**Application of Valrie Kong-Quee to rezone property from R-100 (Residential Medium Lot-100) zoning district to C-1 (Local Commercial) zoning district to allow for an administrative office associated with a landscaping business, at 1422 Rock Chapel Road.**

**PETITION NO: D5-2024-0630 Z-24-1246999 (from September agenda)**

**LOCATION: 1422 Rock Chapel Road, Lithonia, GA 30058**

### STAFF ANALYSIS

SHEET NO.  
**C-100**

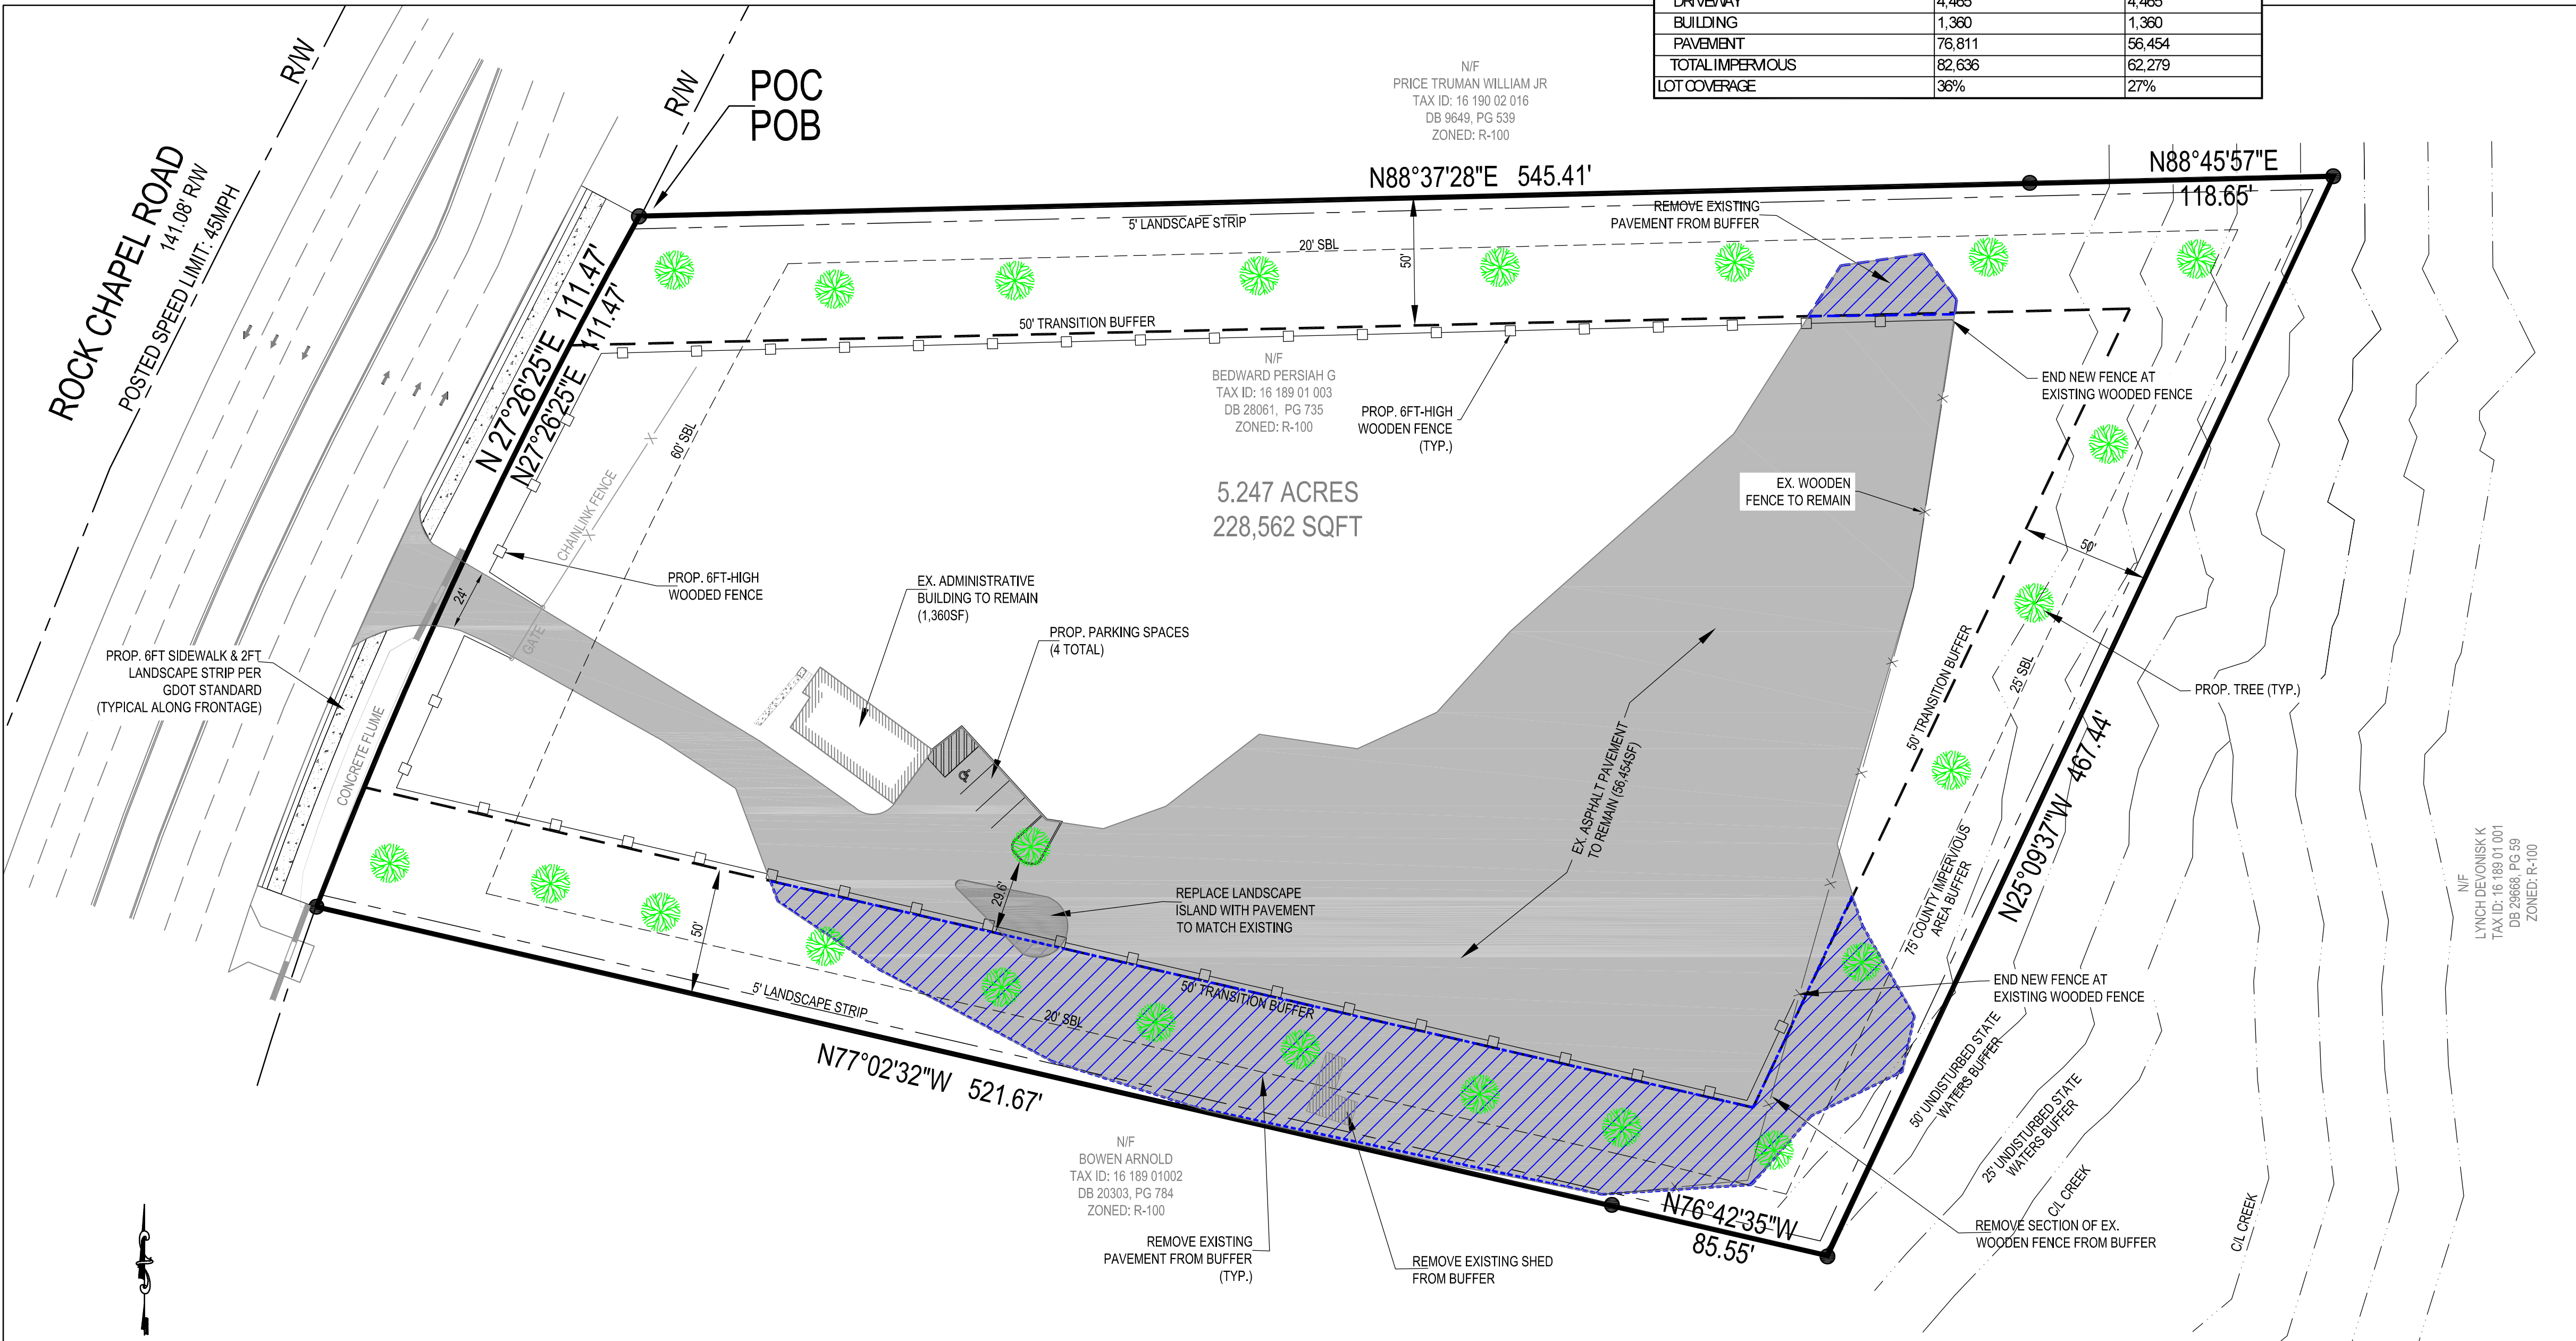
This application was deferred from the July 25<sup>th</sup> Board of Commissioner meeting. Since that time, the applicant has addressed some of Staff's concerns including a submission of an accurate surveyed site plan titled "*Rock Chapel Road Improvements*" (see enclosed) which shows the proposed improvements on the five (5) acre site. The plan shows that the existing paved area in the northwest and southwest corners encroach into the required 50-foot transitional buffer. The applicant has stated their intent to remove these encroachments. The applicant has incorporated four (4) parking spaces as required by *Section 6.1.4 Off Street Parking Ratios* of (Office, Professional) one (1) space for each five hundred (500) square feet of floor area and provides compliance with *Section 5.4.4. Site and parking area landscaping (D 1-10)*. The site plan also shows the required 5-foot landscape strip and 10-foot multiuse path along Rock Chapel Road per GDOT (Georgia Department of Transportation) requirements. Furthermore, the applicant has addressed compliance with Supplemental Regulations A. and B. listed in *Section 4.2.16 Building and Construction Office, Landscape Contractors*. The existing building appears to comply with *the C-1 zoning district requirements of the Non-Residential Dimensional Requirements (Section 2.24.1)*. The applicant has stated there is no proposed new site development or new construction to the existing building or grounds. Interdepartmental Comments are enclosed.

While the proposed office use and existing building comply with the requirements of the C-1 zoning district, the revised plan does present site deficiencies. Additionally, since there are no major intersections within the immediate vicinity, the proposal and site do not appear to be consistent with the policies and strategies of the SUB Character Area to allow for commercial uses at major intersections. Furthermore, it appears the proposal may detract from the SUB character area goals to protect established residential areas and support "spot zoning" that may be inconsistent with the surrounding R-100 zoning and may cause adverse impacts on adjacent and surrounding properties by permitting higher intensity uses allowed by right in C-1. Therefore, upon review of *Section 7.3.5 (A, B, D, and H) of the Zoning Ordinance*, Staff recommends a *denial*. However, should the Board of Commissioners seek approval, Staff recommends the following conditions:

- ✓ The existing truck parking area in the southwestern corner appears to encroach into the required 50-foot transitional buffer ([Sec. 5.4.5. - Transitional buffers](#))

- ✓ This parking area must be paved, and striped and have required landscape islands. The site plan also fails to display parking spaces provided/required per [Section 6.1.4 Off Street Parking Ratios of \(Office, Professional\) one \(1\) space for each five hundred \(500\) square feet of floor area](#) or meet [Section 5.4.4. Site and parking area landscaping \(D 1-10\)](#). The site plan does not show the 5-foot landscape strip and the 10-foot multiuse path along Rock Chapel Road per GDOT (Georgia Department of Transportation) requirements.  
*GDOT typically requires a 2ft grass strip and a 6ft sidewalk along the property frontage. This is shown on the Site Plan.*

- ✓ Compliance with **Supplemental Regulations A. and B. listed in [Section 4.2.16 Building and Construction Office, Landscape Contractors](#). See the "FENCE SCREENING NOTE" on the Site Plan.**

1. The use of the building is limited to "Office Use" within the existing building and not to be expanded.
2. The subject property shall be developed in a manner generally consistent with the surveyed site plan "*Rock Chapel Road Improvements*" submitted to Staff on 8/19/2024. Should there be any conflicts between the Site Plan and the Zoning Ordinance, the Zoning Ordinance shall prevail.
3. Any permit and/or business license shall be withheld until all landscape and site developments come into compliance with *Section 4.2.16 Building and Construction Office, Landscape Contractors, Section 2.24.1 C-1 zoning district requirements of the Non-Residential Dimensional Requirements*, Section

5.4.3 Streetscape Elements and Dimensions, and Section 5.4.4. Site and parking area landscaping (D 1-10), or appropriate variances are granted by the Zoning Board of Appeals.
